Comment Resolution for High-Priority Topics

Howard Heck, Intel

TX $V_{CMPP}/SCMR$ Summary

Summary, new plot for Fig 162A-2

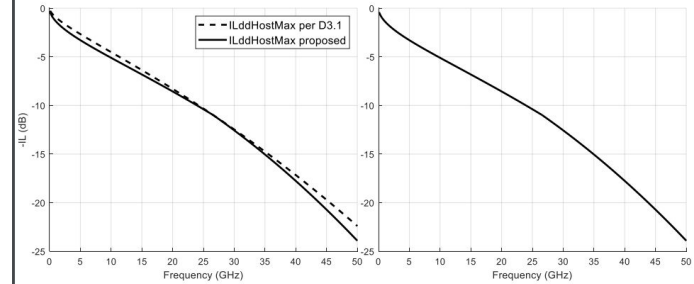
The revision to the mated test fixtures' reference loss to be more like real measurements makes a small difference to the expected Rpeak.

Reduce Rpeak (min) by 1% from 0.397 to 0.393. ← 0.36

PROPOSED REJECT.
This comment does not apply to the substantive changes between IEEE P802.3ck D3.0 and D3.1 or the unsatisfied negative comments from previous drafts. Hence it is not within the scope of the recirculation ballot.
The following related presentation was provided for review by the task force:
https://www.ieee802.org/3/ck/public/22_04/dawe_3ck_02_0422.pdf
The comment does not provide evidence to support the proposed remedy.
